Planning Panels Victoria

Hobsons Bay Planning Scheme Amendment C133hbay

Panel Report

5 January 2023

Figure 6 Proposed Walker Street rezoning

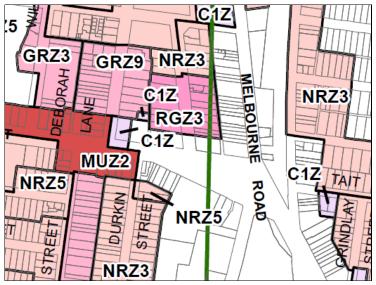
The Amendment proposes to rezone the GRZ1 area to a mixture of RGZ3 (Newport Medium Density Residential area) in the central area of Walker Street, and NRZ3 (Heritage areas) in the northern area of Walker Street subject to existing HO23, as shown on Figure 6. The RGZ3 area is within the proposed DDO7 – Area D as shown on Figure 7.

Sarah and Andrew Horsfield (S28) own the property at 6 Walker Street Newport. They opposed the RGZ3 on the basis that it has not been adequately justified and would result in poor planning and design outcomes, particularly at the transition to the NRZ to the north. Ms Horsfield attended the Hearing and submitted it would be more appropriate to apply the GRZ as a transition to the northern area of NRZ3 that is within HO23. She noted this was the only area proposed to be rezoned RGZ3 and because of its small size would contribute little to consolidation objectives.

Figure 7 DDO7 Map 1

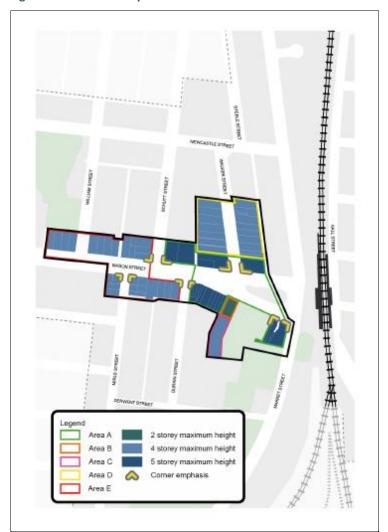
Ms Horsfield raised various urban design issues, including the change from a predominantly single storey streetscape to four storeys in the RGZ3 and five storeys to the east, along Melbourne Road. She submitted these changes should have been accompanied by more thorough assessments of overshadowing, neighbourhood character, private open space and amenity impacts.

The Panel considered whether DDO7 should be removed from the RGZ3 area in response to Ms Horsfield's submission about potential conflict between the DDO7 design objectives (the first two design objectives in relation to land uses and frontages) and the RGZ3. Ms Horsfield noted that the only specific design and built form provisions that apply to Area D relate to the heritage

precinct interface. The Panel agrees these design objectives are not directly relevant to the RGZ3 given their greater focus on commercial rather than residential development and are unlikely to assist the planning permit process . The heritage provisions in Table 4 are largely superfluous because the RGZ3 includes a heritage related design objective, and there are other general heritage protection provisions that would be applicable. For these reasons, the Panel is not satisfied that there is any benefit in including the RGZ3 area in in DDO7 (Area D) and recommends that it be removed.

In Design and Development Overlay Schedule 7, remove Area D from Map 1, delete Table 4 and make any other consequential changes that are necessary.

In planning scheme maps 10DDO and 11DDO, remove Design and Development Overlay Schedule 7 from the area to be zoned Residential Growth Zone Schedule 3 (Area D).

Figure 8 Oxford Street HO23

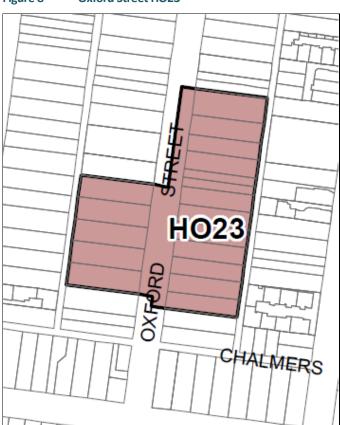
The Amendment proposes to apply HO23 to properties in Oxford Street shown in Figure 8, being 33 to 41 and 34 to 56. HO23 is an existing HO.

- 7. Remove 33, 34, 35, 36 and 38 Oxford Street, Newport from the exhibited Heritage Overlay 23, apply the Neighbourhood Residential Zone Schedule 5 and make any other consequential changes that are necessary.
- 8. Remove 54 William Street, Newport from the exhibited Heritage Overlay 23, apply the Neighbourhood Residential Zone Schedule 5 and make any other consequential changes that are necessary.
